City of Portland, Maine - Building or Use Permit Application

Permit No: 03-1074	Issue Date: NOV 05 2003	CBL: 088 K035001
-----------------------	-----------------------------------	---------------------

Past Use: vacant land	Proposed Use: 28' x 40' modular single family dwelling	Permit Fee: \$1,221.00	Cost of Work: \$125,000.00	CEO District: 3
		FIRE DEPT: <input type="checkbox"/> Approved <input type="checkbox"/> Denied		INSPECTION: Use Group: <i>R 3</i> Type: <i>SB</i> <i>Modular/MEMAN Rules</i>

Dept: Zoning **Status:** Approved with Conditions **Reviewer:** Marge Schmuckal **Approval Date:** 10/16/2003**Note:** The assessors's plan and the submitted plan of the site are different configurations - why? - subdivision? **Ok to Issue:**

This plot is from the
Approved Subdivision
PLAN

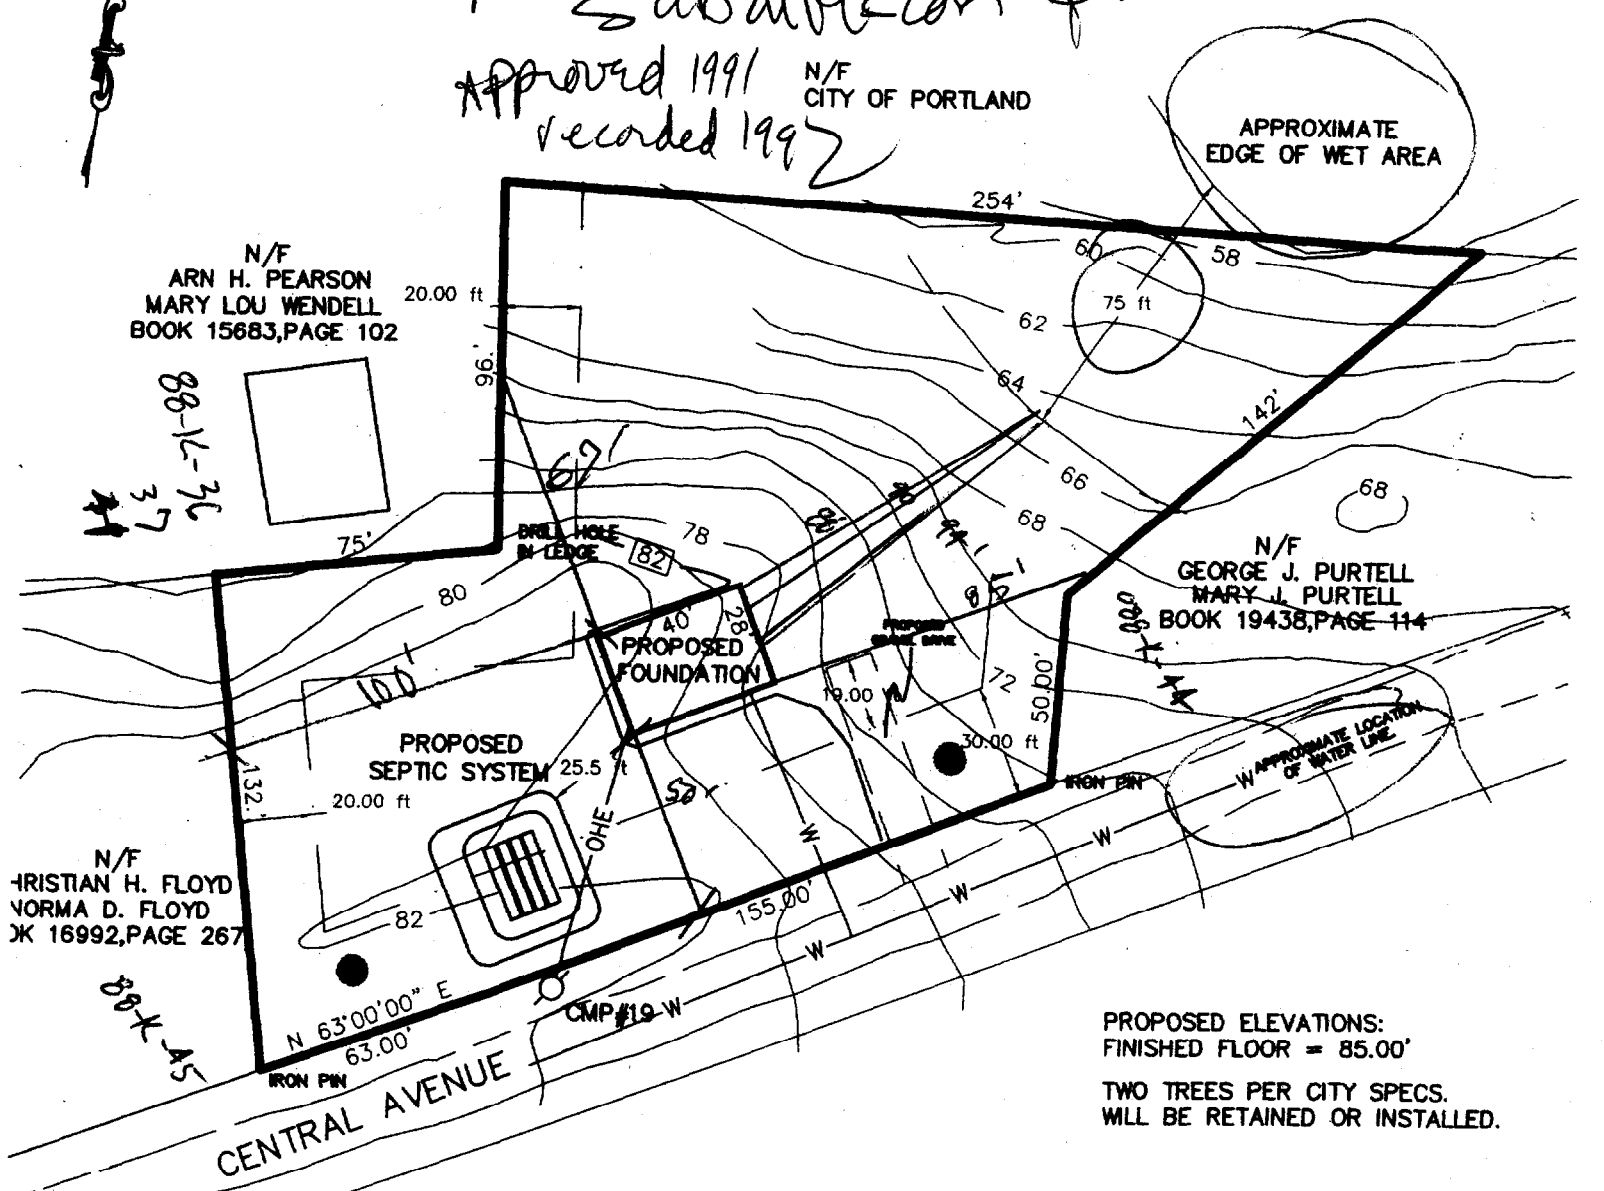
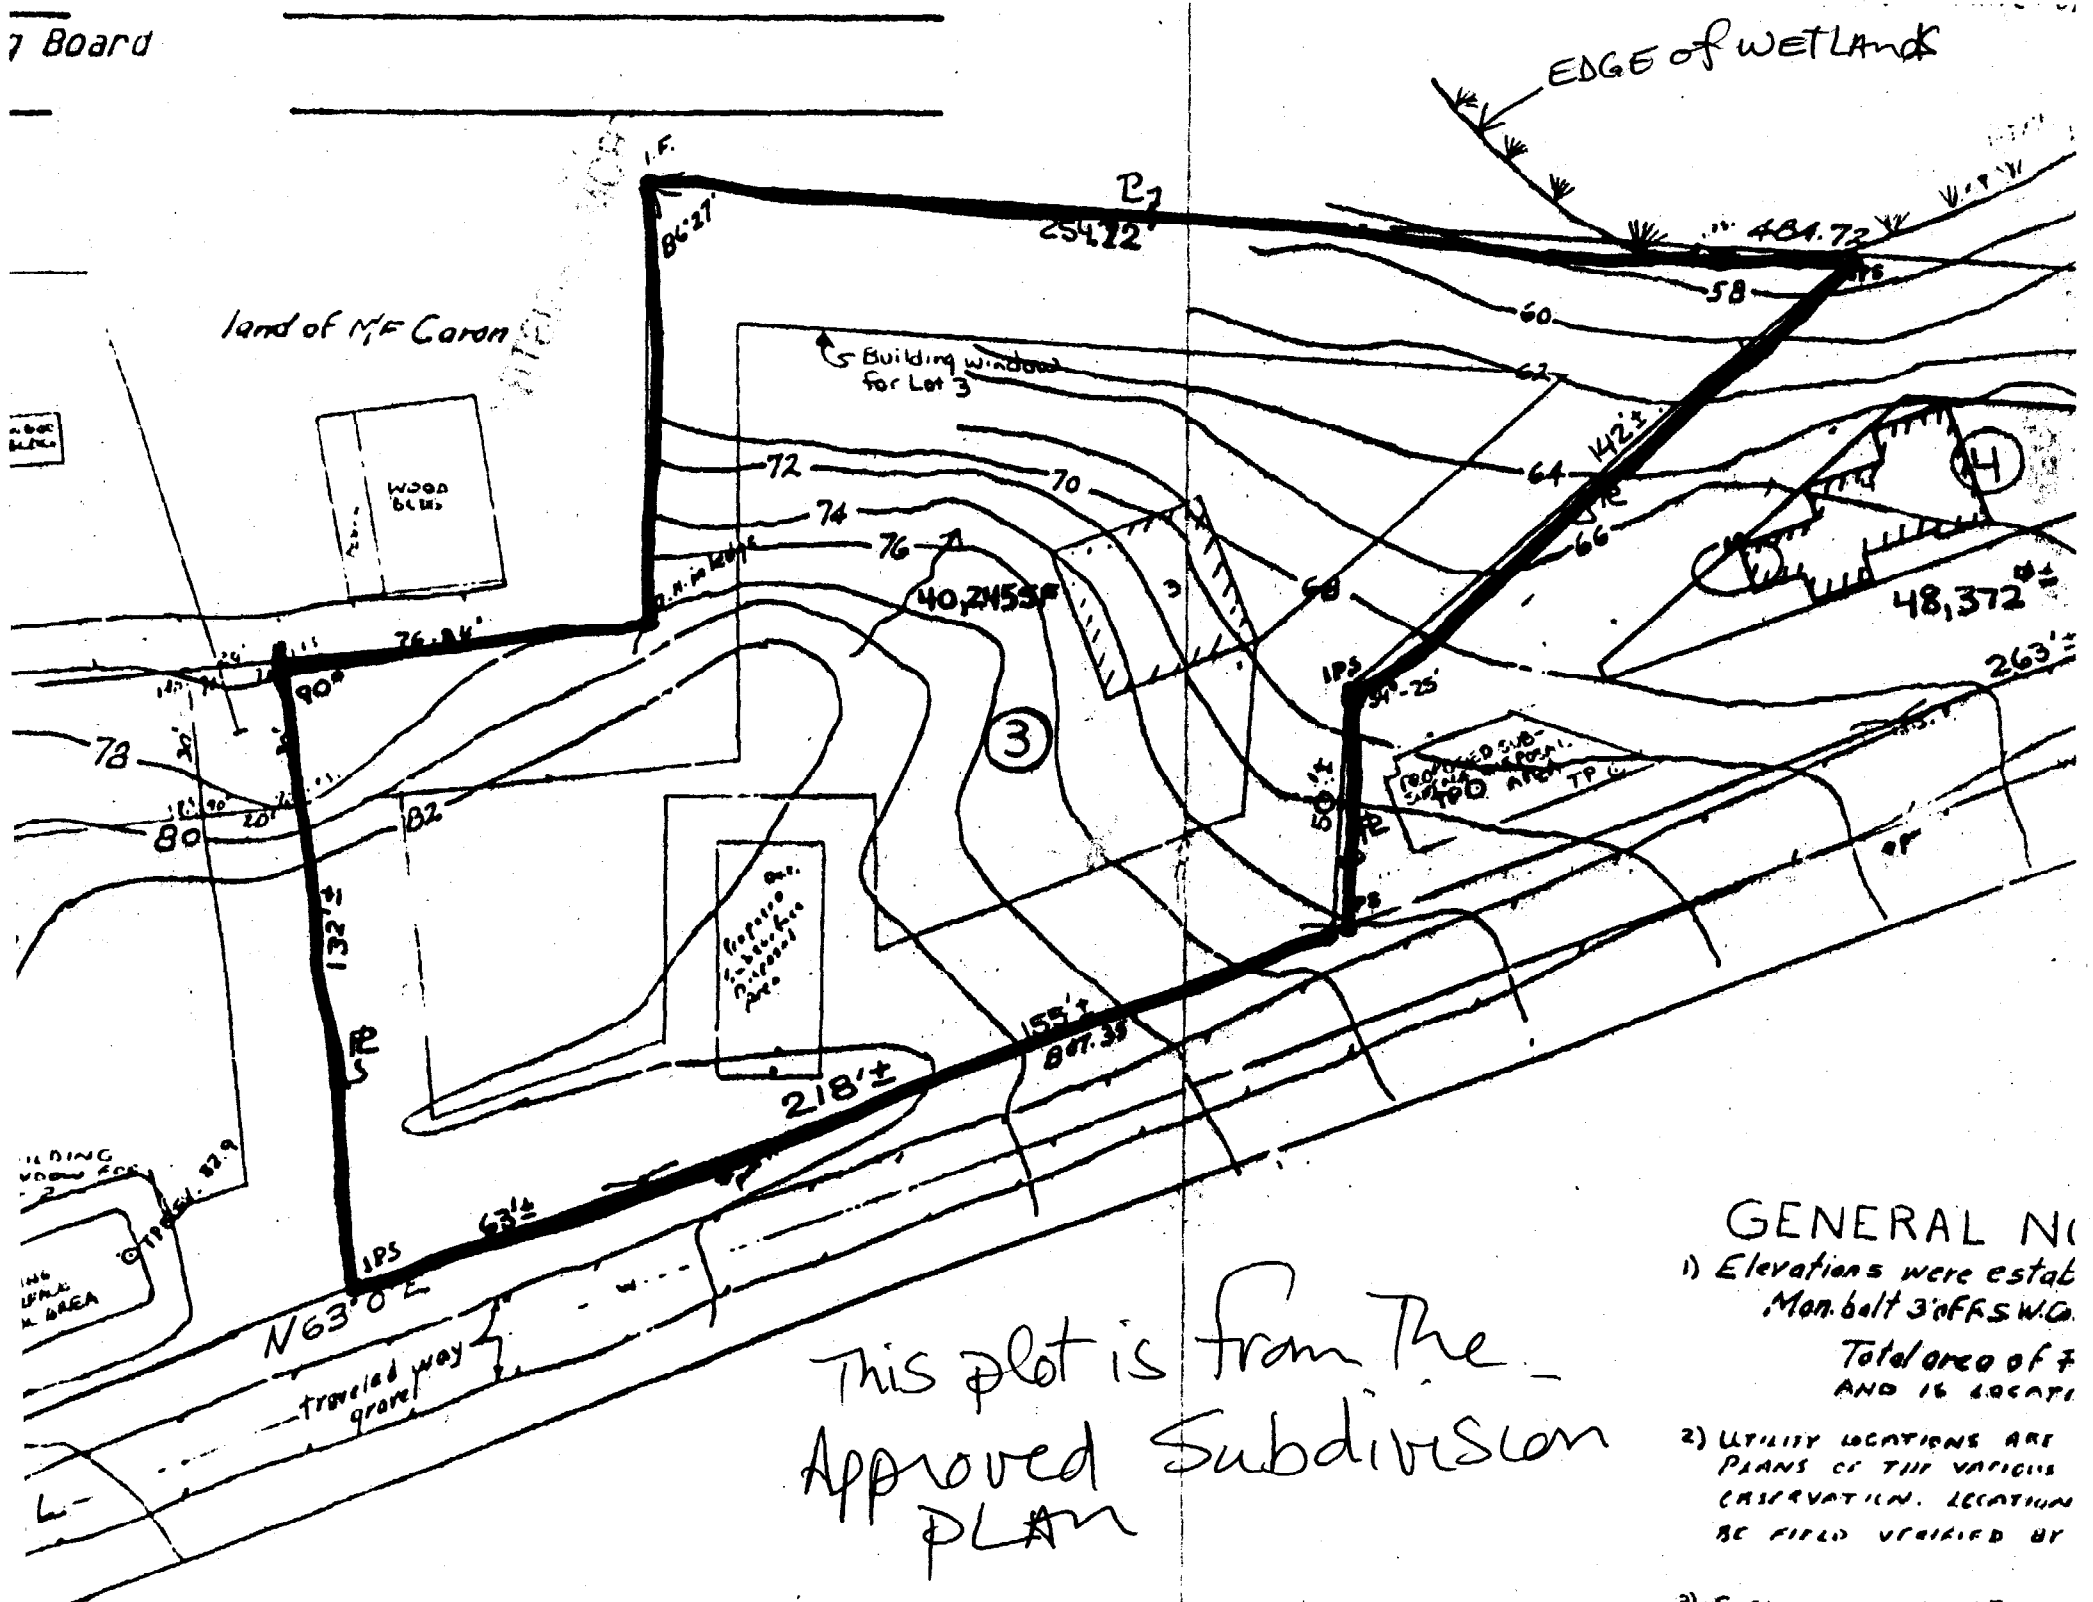
10/1/03 - spoke with Don Hall in assessors - he isn't sure where the changes came from - I called Dick Grant - he says he has a subdivision plan from 1990 & will bring in - I also need a new plan showing one more parking space (2 required)
 1/2/03 Dick Grant brought in the subdivision plan which was approved by planning bd and recorded - The plan states that the City needs something from DEP before signing off.
 10/10/03 I received voice mail from Marybeth Richardson (after faxing copies of plans) saying she does not believe that a DEP permit would be required at this time.
 10/16/03 Received revised site plan showing the two parking spaces

Comments: Marybeth -
I hope you can read these -
let me know if you would require
any permits. I don't think you
would, but I am required to
ask per the conditions on the
approved subdivision plat.

from the current submitted site plan for a building permit application

Received Approved/Recorded
Subdivision plans
Approved 1991 N/F CITY OF PORTLAND
Recorded 1992
